<b>Engineering Change Request</b>		ECR Number	R6191W
Initiator:	BARRY.LI	Date:	Apr-6-22
Review by supervisor:	<i>Sembo</i>	Date:	
Part number description

更新后的包装方式  
Updated packaging method

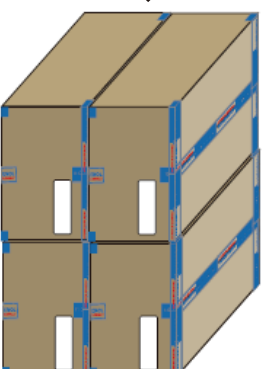
9款配件按如图写的包装数量放入9个PE袋，  
然后在放入1个内箱， 如图示  
9 accessories are put into 9 PE bags according  
to the packing quantity as shown in the picture.  
Then put in an inner carton, as shown

产品主体放入如图所示的内盒, 30件放入一个内盒。  
The main body of the product is put into the  
inner carton as shown in the picture, and 30  
pieces are put into one inner box.

4个内箱装成1个外箱, 2个内箱装配件,  
2个内箱装主体, 每个外箱装60套产品。  
4 inner cartons into 1 outer carton,  
2 inner cartons install accessories,  
2 inner cartons install the main body,  
60 sets of products are packed in  
each outer carton.

60PCS/CARTON (380\*280\*235CM)
